# Access Compliance Report

## Public Rights-of-Way

### (Curb Ramps)

Intersection ID: 42924	Main Street: BRAY_DR	Cross Street: KILRUSH_DR	Location:	S
ADA ID: C4267121DF00	Ramp Type: PerpDiag	Initial Pass/Fail: Fail	Overall Compliance: No	Severity Score: 22.5
Codes/Mitigation Info/Possible Solution		Field Measurements/Component Compliance

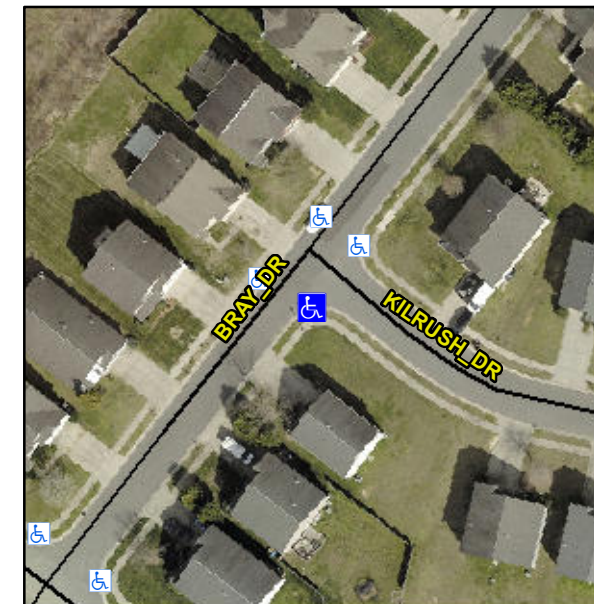
**Not Found, R304.5.1, R304.2.2, R304.5.3**

Compliance	Description	Data	Compliance	Description	Data
N/A	Ramp Length (in)	44.0	No	Ramp Slope (%)	8.4
No	Ramp Width (in)	39.0	No	Ramp XSlope (%)	2.6
N/A	Flare Type LT	N/A	N/A	Flare Type RT	N/A
N/A	Flare Slope LT (%)	N/A	N/A	Flare Slope RT (%)	N/A
N/A	Flare Traversable LT?	N/A	N/A	Flare Traversable RT?	N/A
N/A	Landing Length (in)	N/A	N/A	DWS Provided?	N/A
N/A	Landing Width (in)	N/A	N/A	DWS Contrast?	N/A
N/A	Landing Slope (%)	N/A	N/A	DWS Length (in)	N/A
N/A	Landing X Slope (%)	N/A	N/A	DWS Full Width?	N/A
N/A	Landing Curb? (Y/N)	N/A	N/A	DWS Offset (in)	N/A
N/A	Shared Landing?	N/A			
N/A	Gutter Ponding?	N/A	N/A	Gutter Slope (%)	N/A
N/A	Gutter Lip Ht (in)	N/A	N/A	Gutter X Slope (%)	N/A
N/A	Painted X Walk1?	No	N/A	Painted X Walk2?	No
	X Walk 1 Direction	To NE		X Walk 2 Direction	To NW
N/A	X Walk 1 Width (in)	N/A	N/A	X Walk 2 Width (in)	N/A
	X Walk 1 Slope (%)	4.6		X Walk 2 Slope (%)	2.4
	X Walk 1 X Slope (%)	1.9		X Walk 2 X Slope (%)	2.7

**Remove & Replace Curb Ramp With Two New Directional Ramps or Equivalent.**
